March 31, 2009
NRC:09:030

Supplemental Response to Third Request for Additional Information Regarding ANP-10278P, "U.S. EPR Realistic Large Break Loss of Coolant Accident Topical Report" (TAC No. MD4978)

Response to Third Request for Additional Information—ANP-10278P
“U.S. EPR Realistic Large Break Loss of Coolant Accident Topical Report”
(TAC No. MD4978)

**Figure 31-1: Design Certification Containment Pressure Comparison
Comparison with Design Certification Submittal**

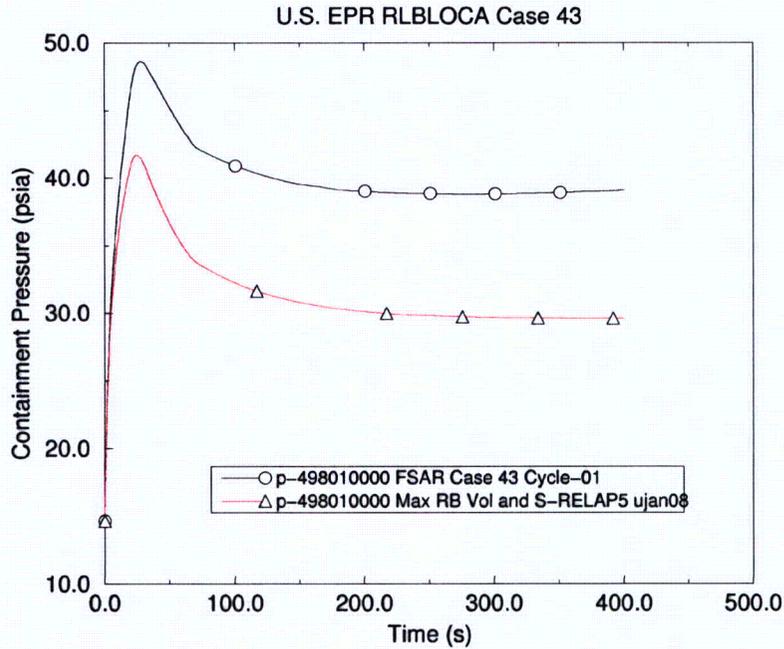
RAI 31: *The staff had expressed concerns regarding the insensitivity of downcomer nodalization on downcomer boiling following large break LOCAs (Reference 2) ["Realistic Large Break LOCA Methodology for Pressurized Water Reactors," EMF-2103(P)(A) Revision 0, FANP Richland, Inc., April 2003]. Staff requests that AREVA quantify the downcomer boiling impact on the EPR RLBLOCA results. It is noted that the staff had also agreed (Reference 2) that with the high containment pressures and PCTs of the order of less than 1800 °F, sufficient margin exists relative to the 10CFR50.46 criteria to not warrant further investigations. However, should PCTs increase above 1800°F and/or the containment design result in pressures below the containment design pressure in the order of 30 psia, the staff plans to establish the limitation of this RLBLOCA method regarding downcomer boiling modeling.*

] This effect is shown in Figure 31-1
